*Energy Harbor Nuclear Corp.  
Beaver Valley Power Station  
P.O. Box 4  
Shippingport, PA 15077*

Subject:  
Beaver Valley Power Station, Unit Nos. 1 and 2  
Docket No. 50-334, License No. DPR-66  
Docket No. 50-412, License No. NPF-73  
Response to Request for Additional Information Regarding Generic Letter 2004-02  
(EPID L-2017-LRC-0000)

Energy Harbor Nuclear Corp. Response to March 23, 2021  
Request for Additional Information,  
Related to Closure of Generic Letter 2004-02

**Figure RAI 4-1: Comparison of Vogtle Test Cases – Total Penetrated Fiber at Plant Scale (Reference 8)**

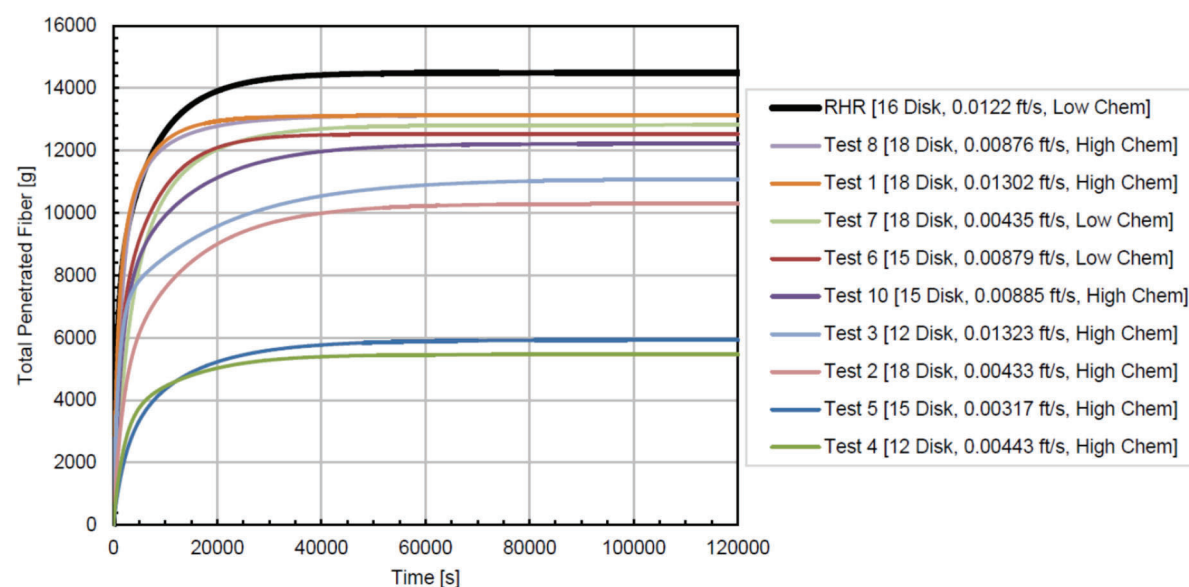
**a. The evaluation of the test flow rate for penetration testing for Unit 1 (pg 42 of 62) states that a higher flow rate forces large fibers onto the strainer earlier in the scenario which increases the filtration efficiency of the debris bed. This is not consistent with the fact that testing has consistently shown that higher flow rates lead to increase penetration. The discussion under (1) contradicts empirical findings from strainer penetration testing. The discussion under (2) did not clearly state the test flow rate and compare this to the plant flow rate. The baseline for the 30% flowrate increase is unclear. Provide the plant and test flow rates, and discuss what the 30% flow increase is referenced to.**

Fiber bypass testing results from the Vogtle Supplemental Response (Reference 8) are presented graphically in Figures RAI 4-1 and RAI 4-2 below.

Pertinent data is summarized in Table RAI 4-1, using a visual approximation of the maximum quantities of total penetrated fiber (to the nearest 100 grams [g]) from Figure RAI 4-1 and penetrated fiber per disk (to the nearest 0.5g) from Figure RAI 4-2.

The results of Vogtle fiber penetration testing show that a given percentage increase in approach velocity yields an increase in fiber penetration, but of lesser magnitude. The following is true for the pairs of tests listed in Table RAI 4-2:
